Product Change Notification / NTDO-13QXLX842

CCB 6024 Initial Notice: Qualification of MMT as an additional assembly site for selected MTD6508 device family available in 16L UQFN (4x4x0.5 mm) package.

CCB#: 6024
Pre and Post Change Summary
PCN #: NTDO-13QXLX842

Lead Frame Comparison

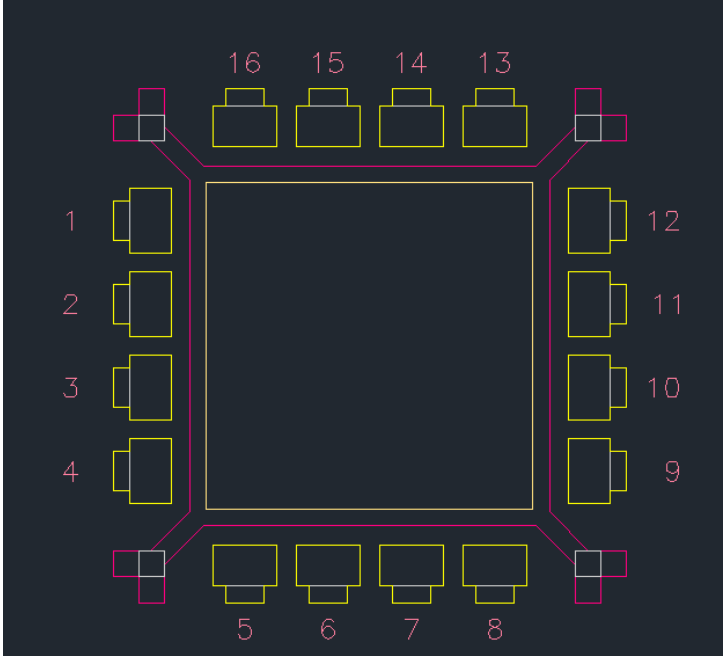
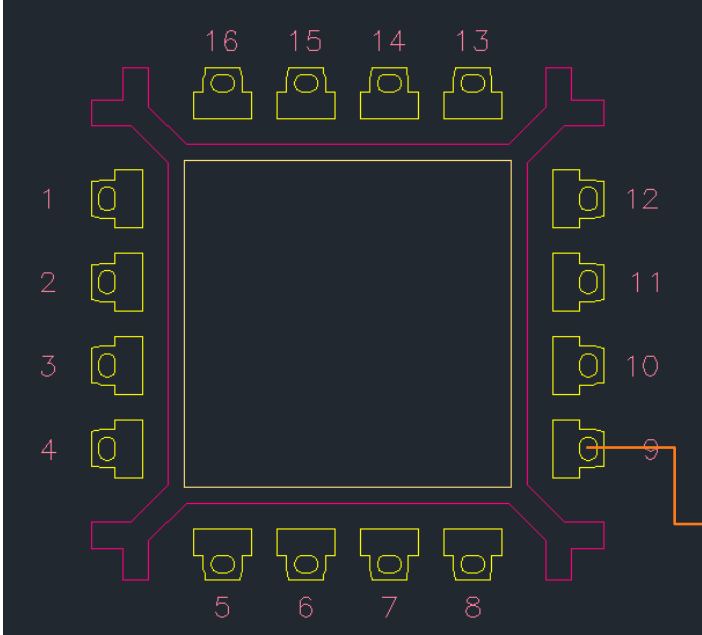
NSEB	MMT								
 <table border="1" data-bbox="343 1056 1011 1163"><tr><td>Lead Frame Material</td><td>EFTEC-64T</td></tr><tr><td>Lead Lock</td><td>No</td></tr></table>	Lead Frame Material	EFTEC-64T	Lead Lock	No	 <table border="1" data-bbox="1508 1045 2175 1153"><tr><td>Lead Frame Material</td><td>EFTEC-64T</td></tr><tr><td>Lead Lock</td><td>Yes</td></tr></table>	Lead Frame Material	EFTEC-64T	Lead Lock	Yes
Lead Frame Material	EFTEC-64T								
Lead Lock	No								
Lead Frame Material	EFTEC-64T								
Lead Lock	Yes

Note: The lead lock hole fills with mold compound during the assembly process and provides improved protection against moisture penetration around the interface edges between pins and mold compound.
